# UNITED STATES PATENT AND TRADEMARK OFFICE

10/529,347

Marco Castello

<b>Office Action Summary</b>	<b>Application No.</b> 10/529,347	<b>Applicant(s)</b> CASTELLO, MARCO	
	<b>Examiner</b> Leonard R. Leo	<b>Art Unit</b> 3744

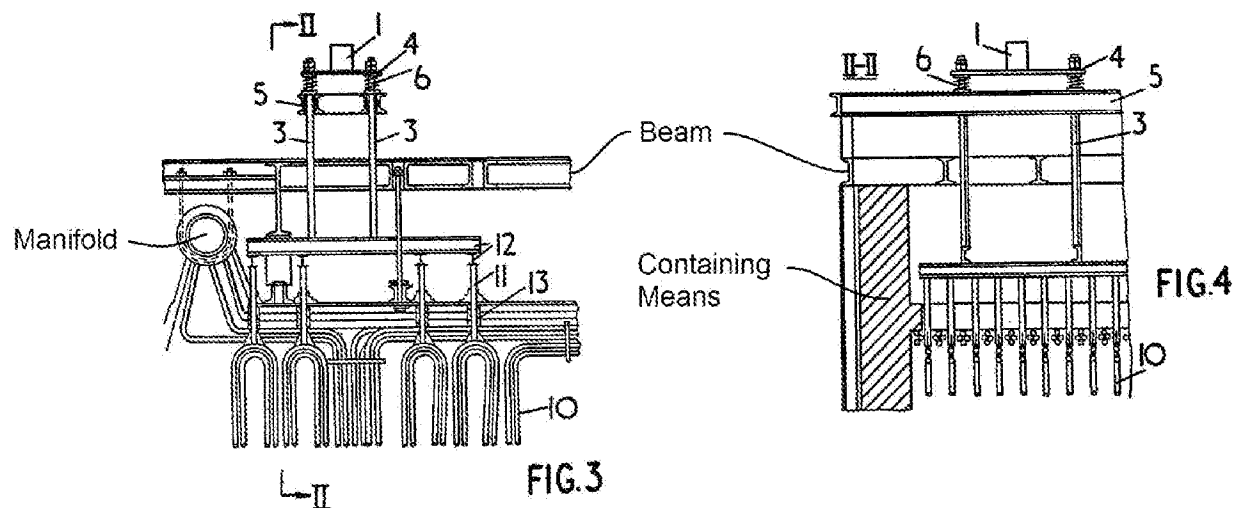
Claims 1, 3, 5-6, 9-16, 18 and 20 are rejected under 35 U.S.C. 102(b) as being anticipated by Kropp et al (GB 1,099,742). Figures 3-4 of Kropp et al discloses a heat exchange unit comprising a tube bundle 10 for heating water; containing means for a heating gas defined, in part by unlabelled vertical walls into which the bundle 10 extends (Figure 4, marked up below); and connection means 5 operatively connected to the upper end of the tube bundle 10 and structurally separate from the containing means.

Regarding claim 3, the connection means 5 extends in a plane perpendicular to the vertically extending tube bundle 10.

Regarding claim 5, Kropp et al discloses shaking means 1 arranged at connection means 5.

Regarding claims 6, 12 and 14, the vertical wall extending above the unlabelled separating plate/frame (i.e. a brick lining) with fluid tight seals 13 is read as defining a part of a “collection tank.”

Regarding claim 9, Figures 3-4 (marked up, next page) of Kropp et al discloses the heat exchange apparatus including an unlabelled manifold connected to the tube bundle 10 is vertically supported by an unlabelled beam, which in turn is supported on top of the containing means.

Regarding claims 10-11 and 13, Figures 3-4 (marked up, above) of Kropp et al discloses an unlabelled separating plate/frame (i.e. a brick lining) with seals 13 partially crossed by the tube bundle 10.

Regarding claim 16, Kropp et al discloses hooking means 3 arranged at the end of the tube bundle 10 and operably connected to connection means 5.

Regarding claim 18, Figure 3 of Kropp et al discloses the tube bundle 10 extending in a Z-direction (i.e. left to right).
